**AGENDA FOR REGULAR MEETING  
VILLAGE OF TINLEY PARK  
PLAN COMMISSION  
April 2, 2015 – 7:30 P.M.  
Council Chambers  
Village Hall - 16250 South Oak Park Avenue**

**DAVITA DIALYSIS CENTER (former Eiche Turner) – 16767 S. 80<sup>TH</sup> AVENUE - SITE PLAN APPROVAL, RE-SUBDIVISION PLAT, AND VARIATIONS FOR A NEW MEDICAL FACILITY** (Commissioners McClellan and Ficaro)

**E&B LIQUORS (former Family Video Store) – 16948 OAK PARK AVENUE – SITE PLAN APPROVAL AND SPECIAL USE PERMITS FOR A PACKAGE LIQUOR STORE AND A MIXED-USE BUILDING** (New Item)

**ITEM #2: DAVITA DIALYSIS CENTER (former Eiche Turner property) – 16767 S. 80TH AVENUE – SITE PLAN APPROVAL, RE-SUBDIVISION PLAT APPROVAL, AND VARIATIONS FOR A NEW MEDICAL FACILITY (New Item)**

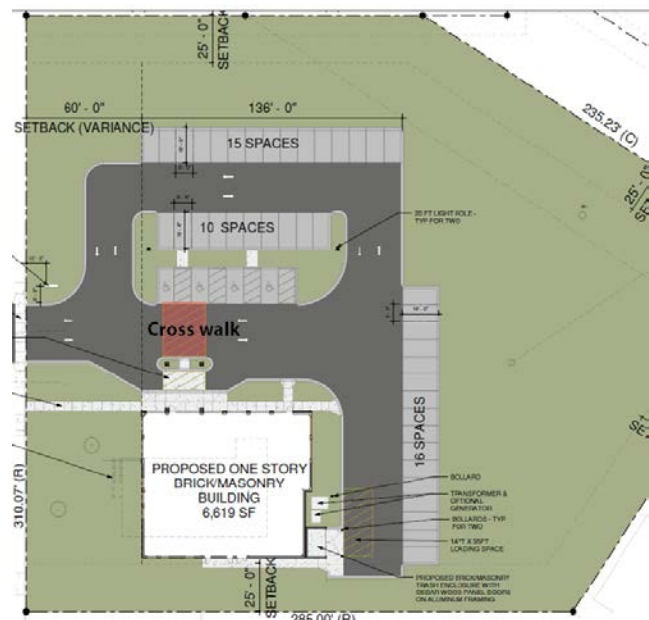
***(NEW) Open Item #1 Legal review of easement language on Re-Subdivision Plat.***

***A Plat of Re-Subdivision has been provided for your review. The location and size of the cross access easement is defined, however Staff and the Village Attorney recommend that the second paragraph related to the cross access easement be struck. Construction and responsibilities can be negotiated at a later date.***

## LANDSCAPE

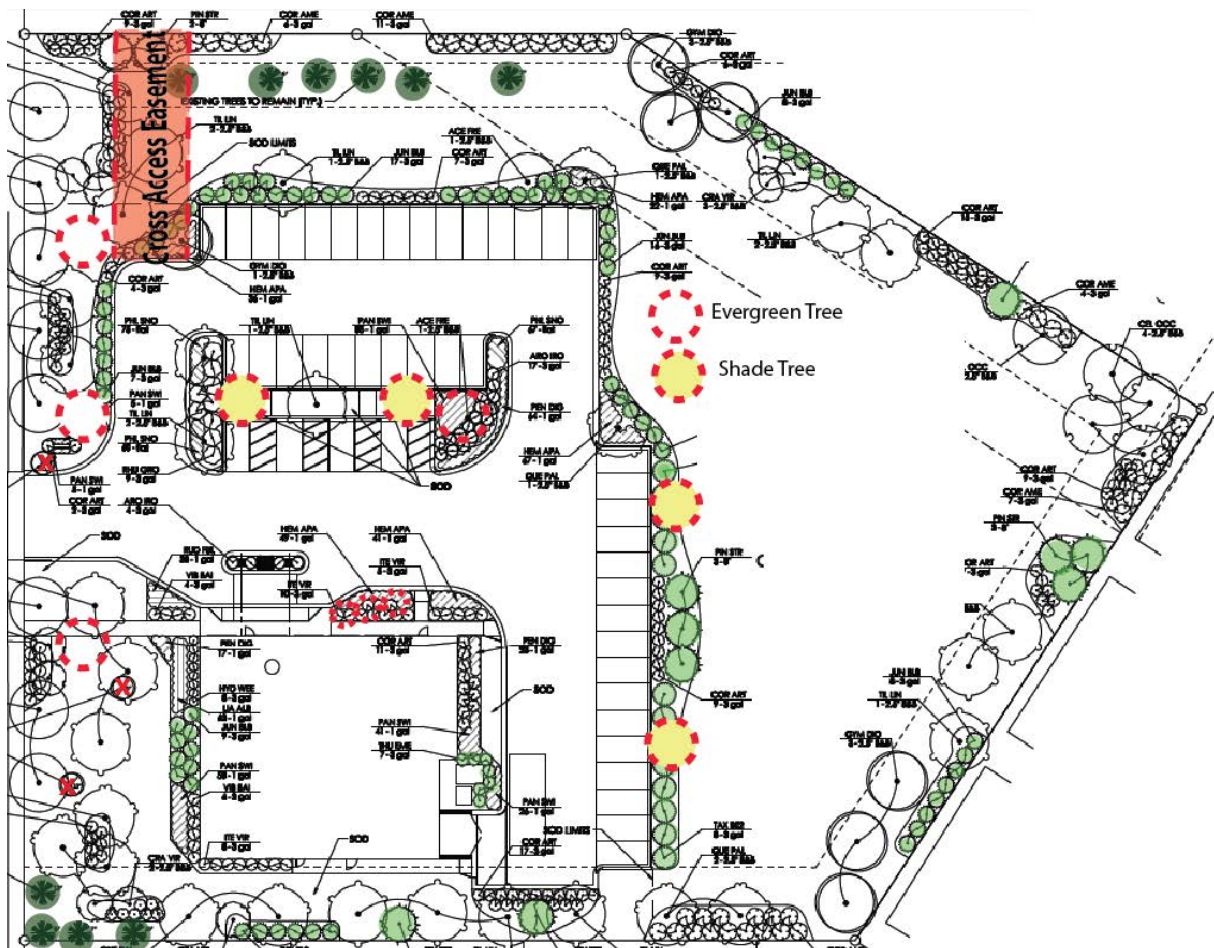
The intent of the Village's Landscape Ordinance is to utilize landscape materials to enhance proposed development, soften the impact of parking areas, provide a buffer between land uses, and create an overall quality aesthetic for the site. The Landscape Plan has been revised to reflect Staff's concern regarding location and adequacy of bufferyards and amount of evergreen material in the bufferyards to provide year round screening. Evergreen plantings have been highlighted in green in the plan below.

**Bufferyards:** Bufferyards have been provided along the perimeter of the property. A Bufferyard “C” has been provided along 80<sup>th</sup> Avenue, which incorporates the street trees per Staff’s recommendation. The parkway along 80<sup>th</sup> Avenue represents a harsh growing environment due to salt spray and traffic fumes; therefore, the required street trees have been incorporated into the required bufferyard rather than within the parkway. Along the north property line, the Applicant has provided a Bufferyard “B” which meets Landscape Ordinance requirements. The remaining property lines abut the church property at the northeast property line and the residential properties at the south and southeast property lines. The residential properties include detached garages at the property line, along with a chain link fence, which provides a structural screen between the proposed office use and the multi-family structures. These areas meet bufferyard requirements and have included additional evergreen material to provide year round screening per staff recommendation. There are several existing evergreen trees along the north property line that will be preserved.

A cross-access easement will be recorded with the plat to provide future cross-access if the property to the north redevelops. Staff recommends relocating any proposed landscaping out of the cross-access easement.

In addition to bufferyard requirements, the Site Plan must meet screening requirements for the parking areas. Parking areas are required to be “screened from the view of adjacent properties and streets by evergreen planting that will attain a height of three (3) feet within three (3) years”. The Applicant has revised their plans to provide additional screening along the perimeter of the parking lot, which includes a fair amount of evergreen material. Some deciduous trees have also been provided in the parking lot to provide some shade to the parking lot. Staff recommends relocating some of the trees that are shown in the cross-access easement area into the parking lot interior to provide additional shade. Staff also recommends providing a few more evergreen trees to balance the front façade and provide some year round screening in the parking lot.

The Landscape Plan indicates some areas where it appears the shrubs are located too far apart to create an adequate screen. The landscape architect has requested that shrub spacing be indicated on the plan.

**Open Item #3: Shrub spacing is not indicated on the plan.**

***The Applicant has revised the Landscape Plan and removed plant material from the cross access easement area.***

***The Applicant has revised the Landscape Plan and provided additional plant material as requested.***

***The Applicant has revised the Landscape Plan and provided information on shrub spacing on the plan.***

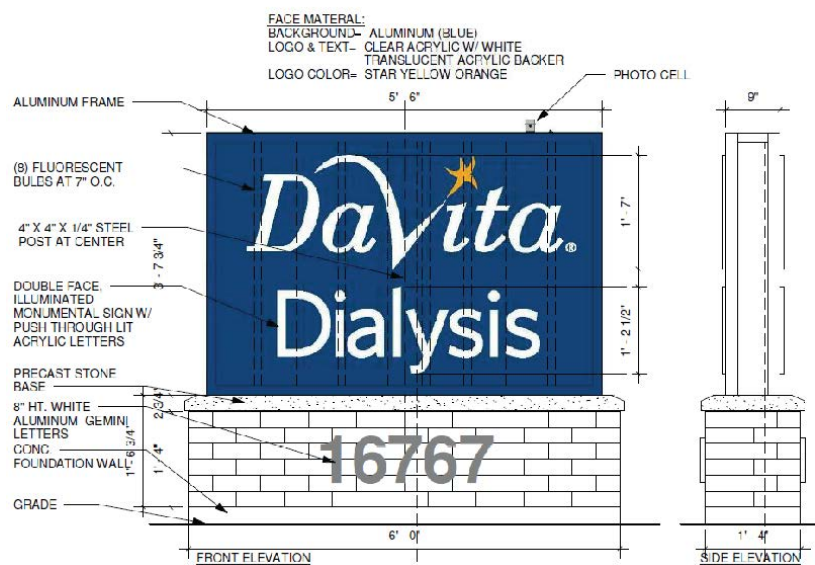
***Open Item # 5: The north façade provides awning over two (2) windows, which appears inconsistent with the overall design.***

***The Applicant has provided awnings for all four (4) windows on the north façade (east of the porte-cochere). The architect has modified the window openings to accommodate the awning for the westernmost window since it conflicted with the overhang of the porte-cochere. Elevations are provided in the Commissioner's packet.***

The Applicant also addressed Staff's concern regarding the lack of significant reveals along all facades. A 2" brick reveal was originally proposed, which Staff felt was unperceivable from the public right-of-way and would not provide the shadow lines as indicated in the submitted rendering. The Applicant has agreed to double the amount of the reveal and has provided a 4" setback in those specified areas along all facades.

LANDSCAPE PLAN  
LP-100

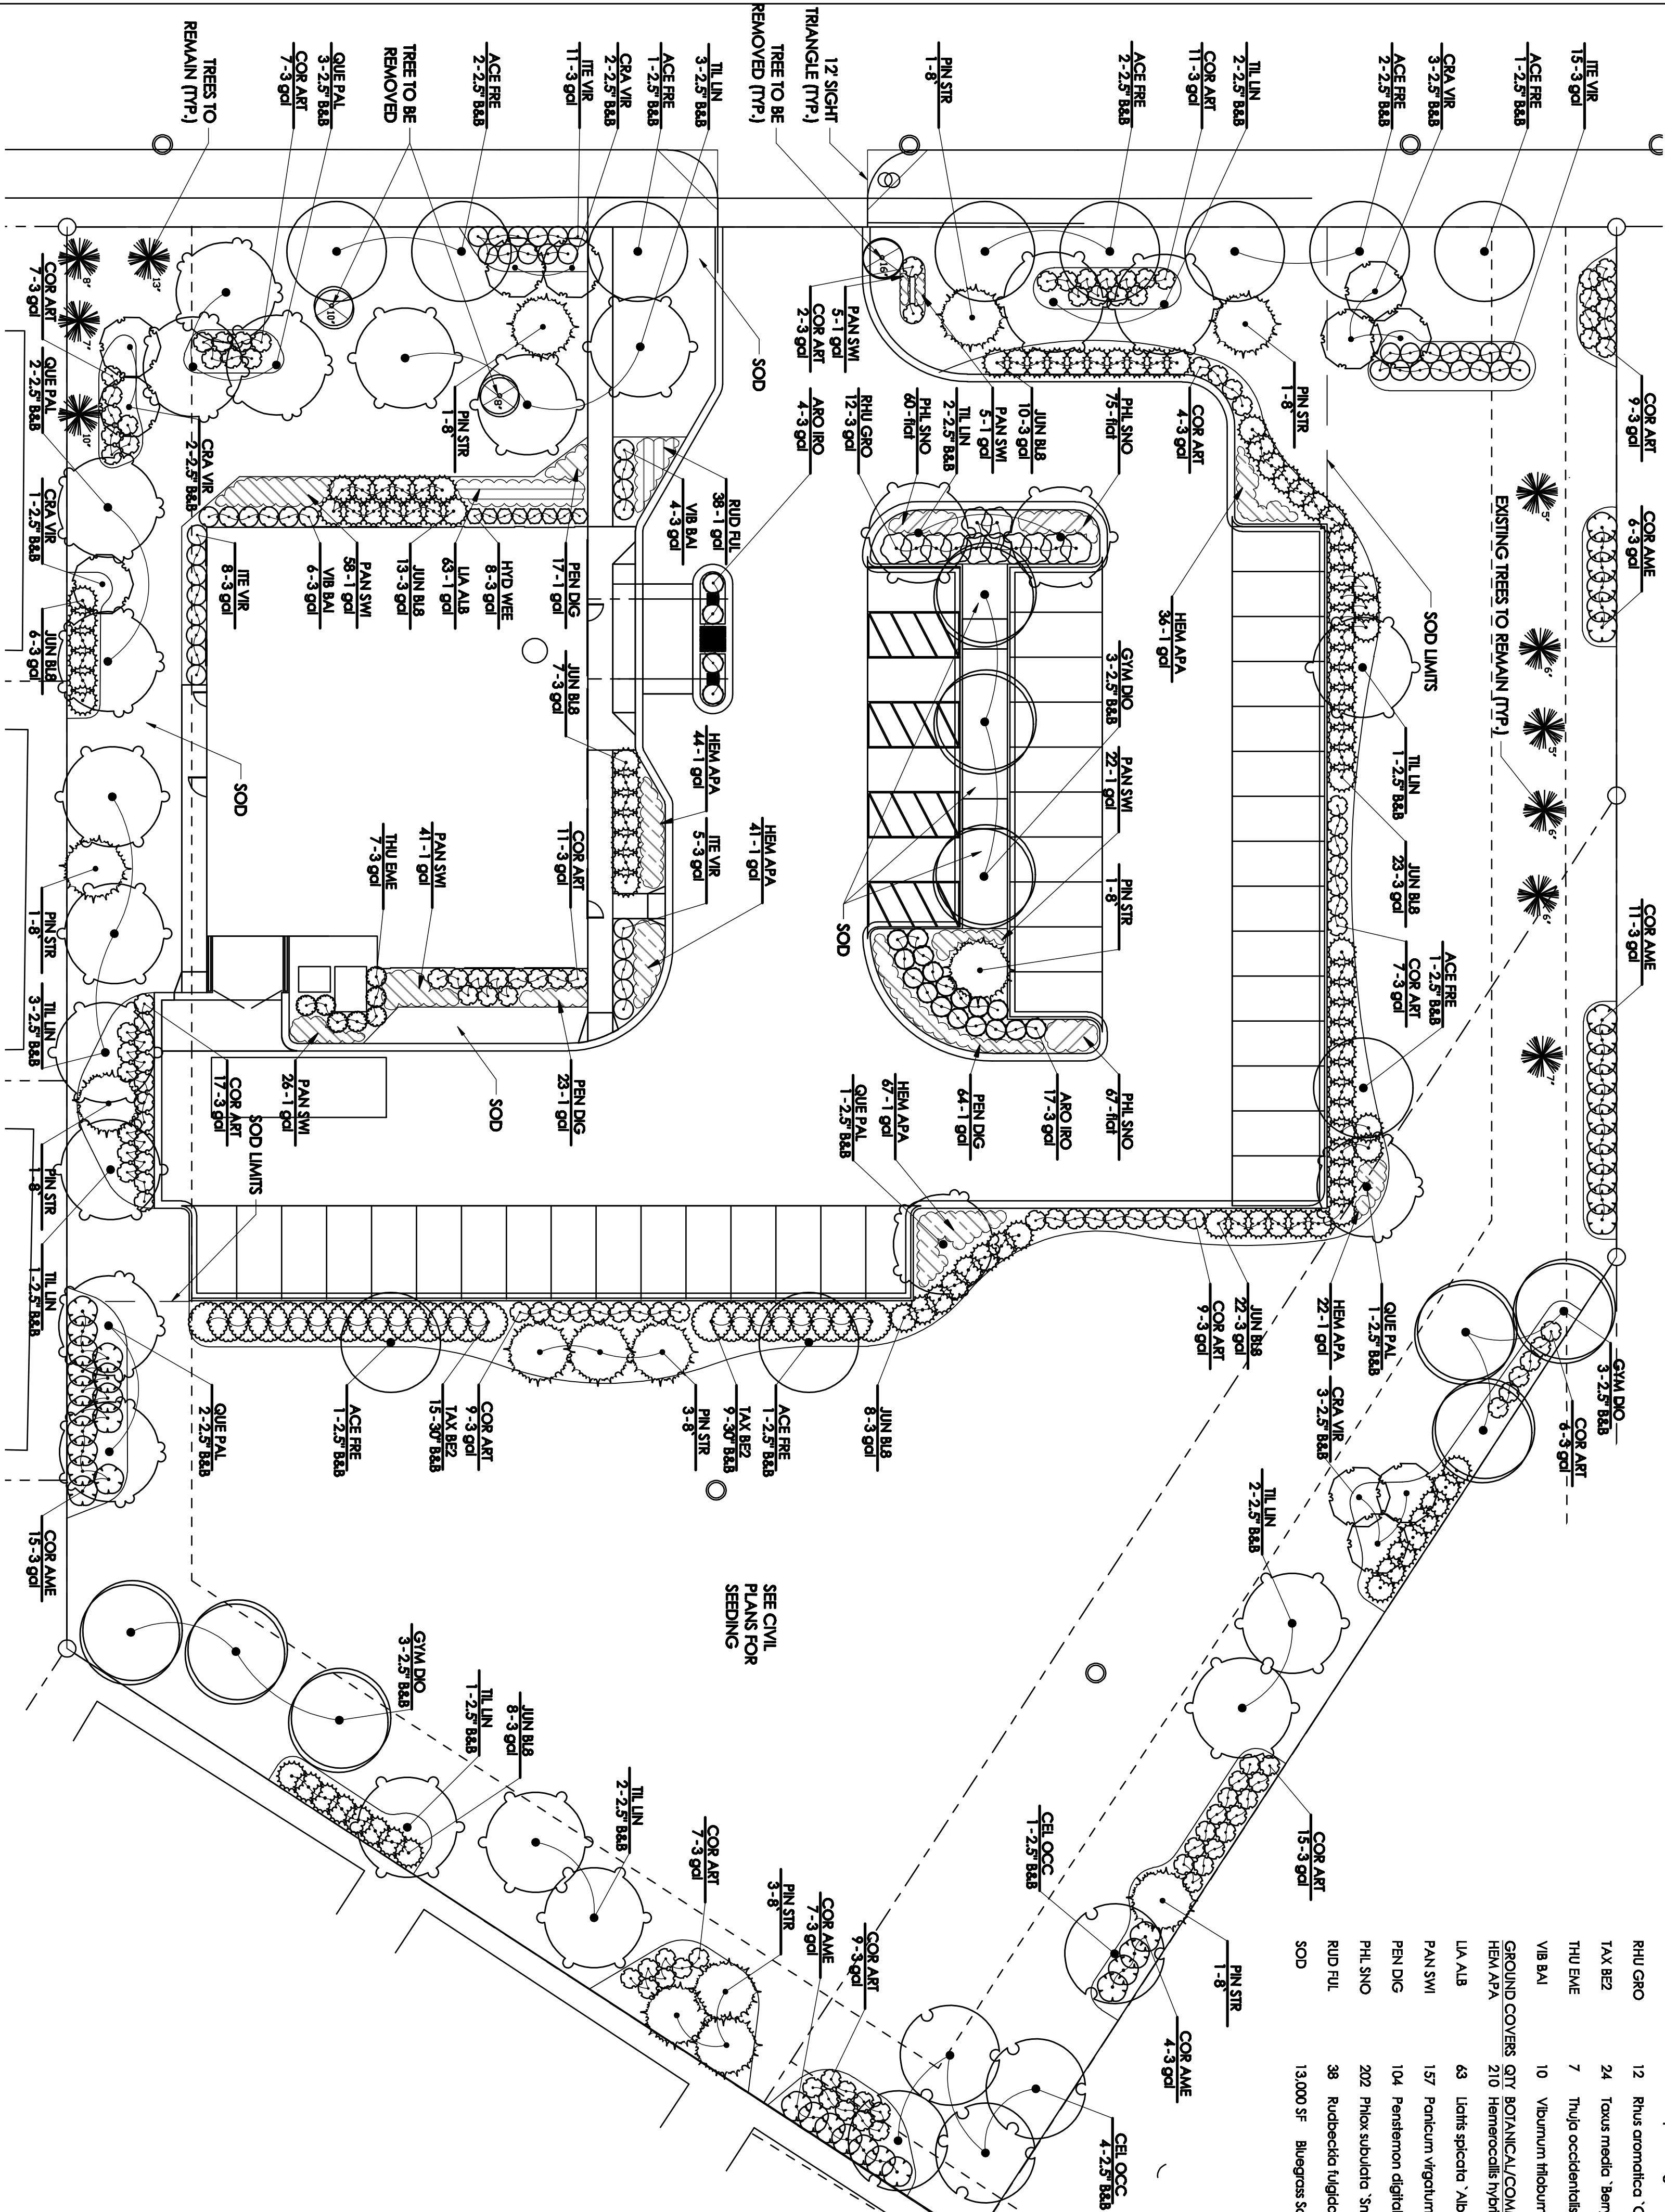
MS. WALLRICH reviewed the landscape plan. Staff is requesting the trees planned for the cross easement area be relocated to the parking lot interior to provide additional shade and additional evergreen screening across the front of the property. She reported minor concerns were also raised regarding shrub spacing that was not indicated on the landscape plan, and requested the landscape plan be revised to include the spacing information.

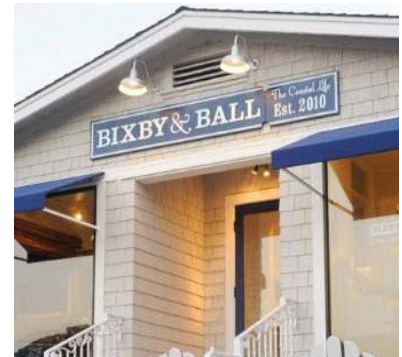
The Applicant has not submitted any signage plans. The Applicant has proposed lighting in the renderings submitted to Staff. The goose neck lighting offers an attractive enhancement to the front façade. Staff would like to note that the proposed goose neck lighting on the façade may need to be move further toward the roof line to allow for an adequate sign band area between the awning and the roof line. Also, the use of the columns is an effective way of distinguishing between storefronts but may present issues with signage if tenants occupy more than one space. It appears that this building could provide for up to four tenants; Staff requests to ensure that there will not be signage placement issues if the space is divided up differently in the future.

*Open Item #5: Move the goose neck lighting on the front façade upward to create a more defined area for a sign band for the liquor store and the other tenant space.*
